Harrell Design Group, PC AMENDMENT 02 July 11, 2024

RENOVATE SPACE FOR LOGISTICS (B-1) VA PROJECT #564-24-104

Veterans' Healthcare System of the Ozarks

HDG Project Number: 19022-A

Engineering Service VETERANS HEALTH CARE SYSTEM OF THE OZARKS VA U.S. Department of Veterans Affairs

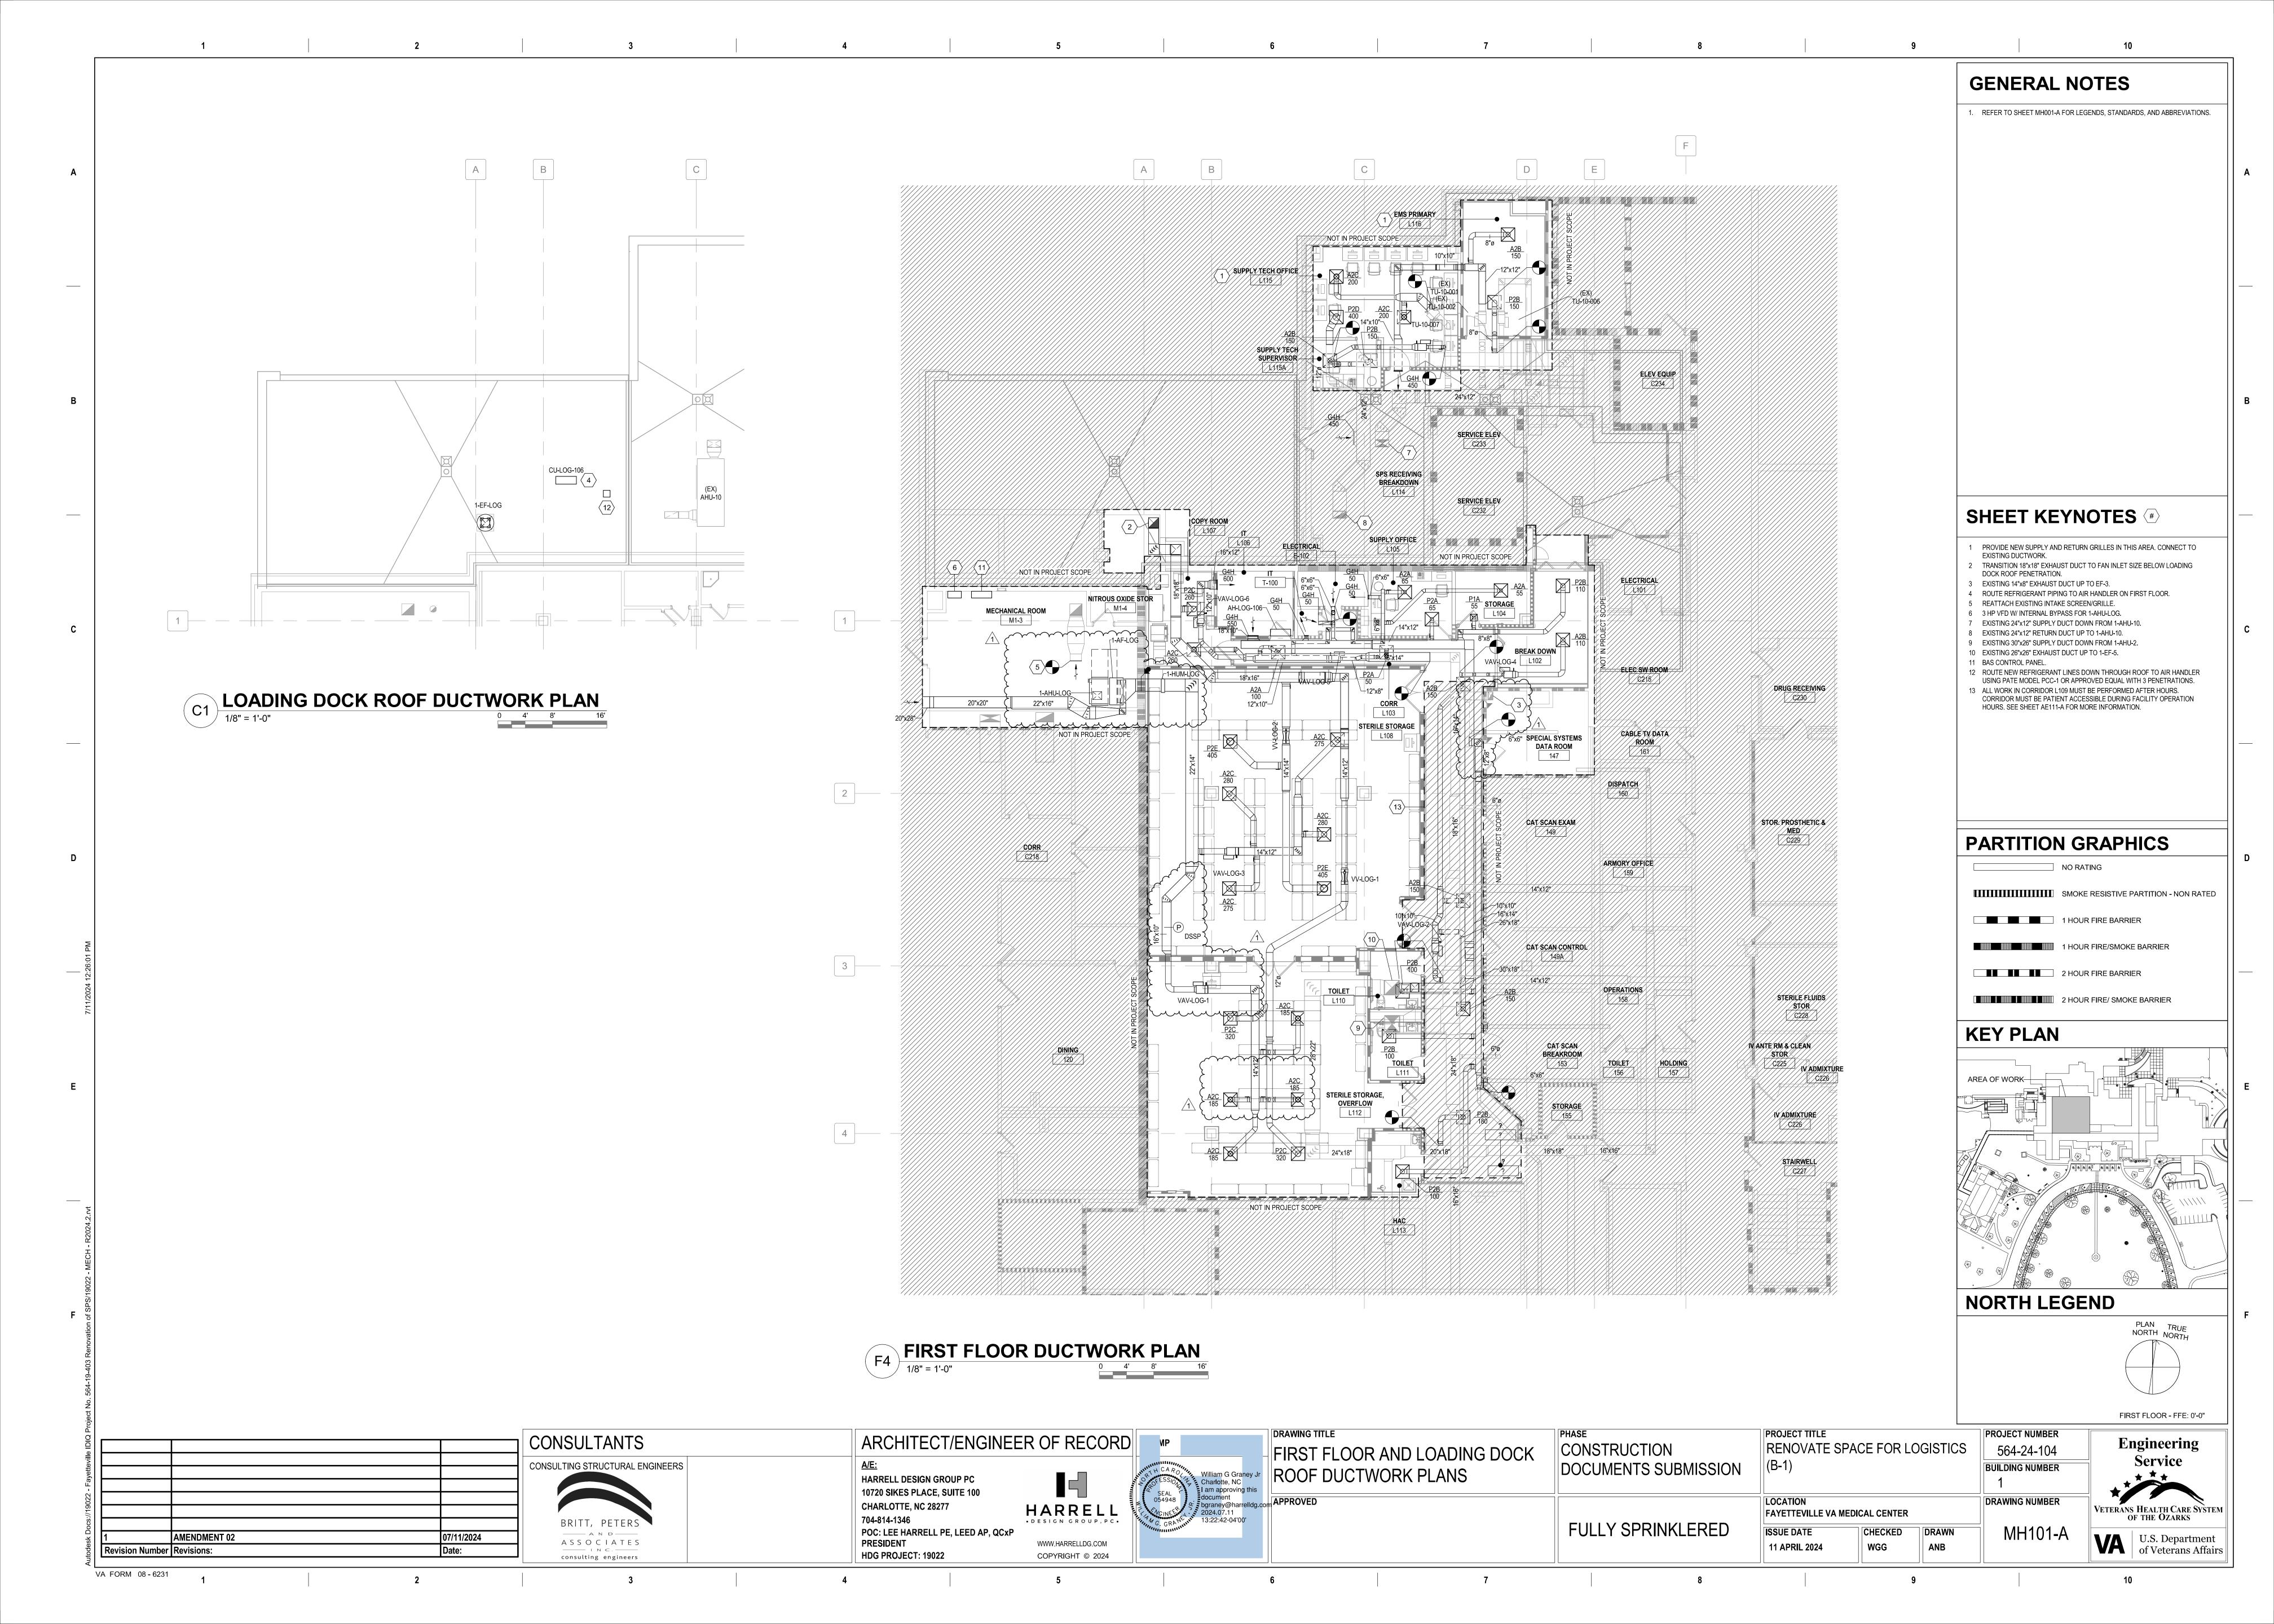
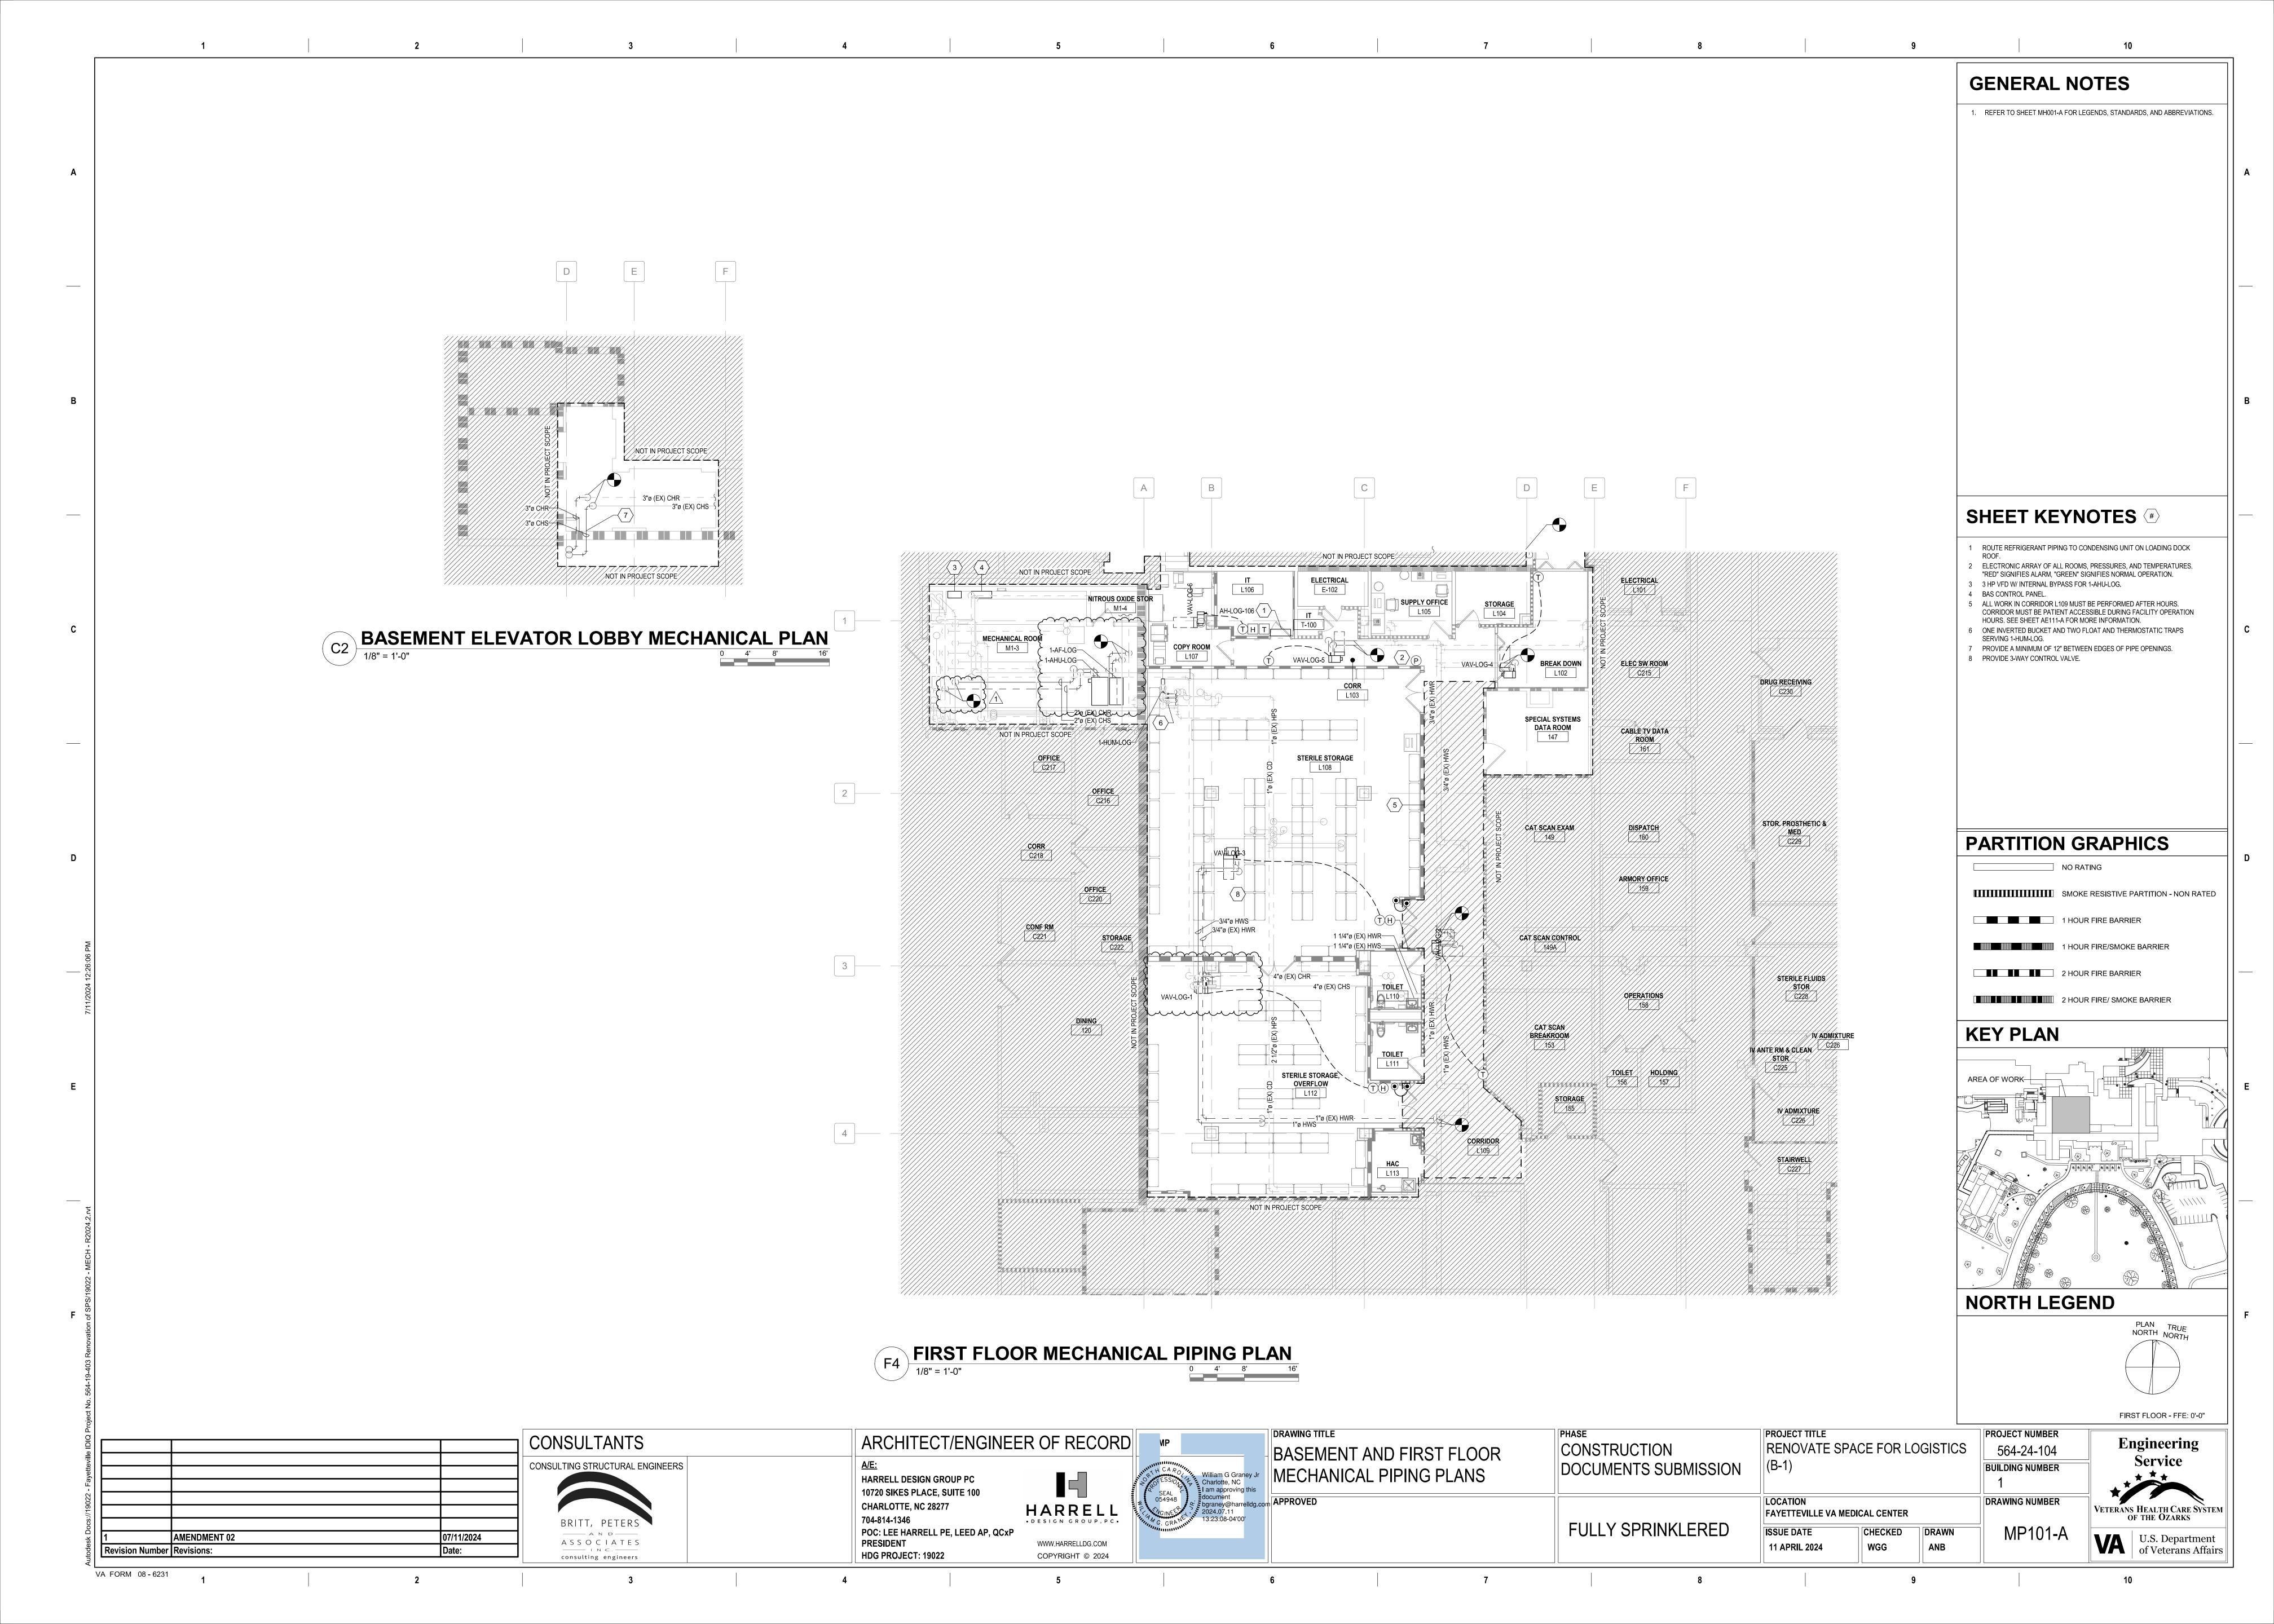
- i. The Signage Schedule was updated to reflect the correct room names, room numbers, and quantities of all signage.
- ii. Corridor L109 was added to the Finish Schedule.
